Stinson Service Bulletin #266 (Formerly Piper Service Bulletin No. 114)

February 1, 1950

Subject: Stinson Rudder Cables Model 108; 108-1; 108-2; and 108-3

PULLEY BRACKET MODIFICATION
STINSON 108

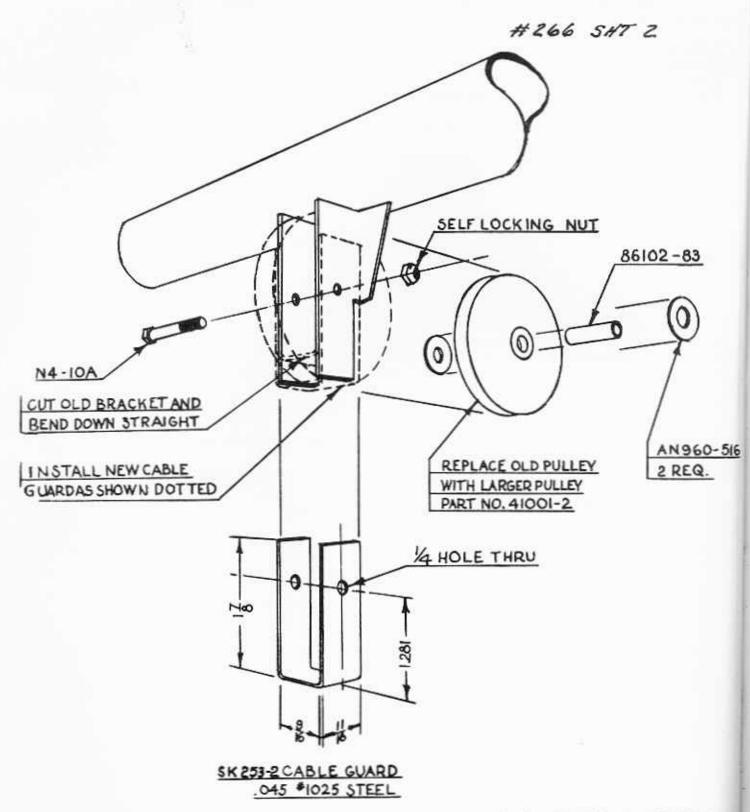
We have received several reports from the field that the core strands of the rudder cables were found to be broken at a point where the cable passes over the An210-3A pulley at fuselage station 18.75, (immediately under rudder pedals.)

The cable strand breakage was caused by too great a degree of bend around the pulley. It is recommended that the pulley modification, as indicated on the accompanying sketch, be accomplished on all subject aircraft. The listed instructions should be followed in performing the modifications:

- 1. Remove the forward belly access door.
- 2. Remove the right and left hand landing gear fairing.
- 3. Peel back the forward edge of the landing gear dust cover strips, which are doped to the metal fuselage cowl, far enough to uncover the pulleys on both sides of the airplane.
- 4. Remove the AN210-3A Pulley.
- 5. Cut the pulley brackets, as indicated on sketch.
- 6. Install two Part Number 41001-2 pulleys and two Part Number SK253-2 Cable Guards.
- 7. If rudder cables show signs of breakage, they must be replaced.
- 8. Redope the landing gear dust cover strips to the fuselage cowl.
- 9. Replace the right and left landing gear fairings.
- 10. Replace the forward belly access door.
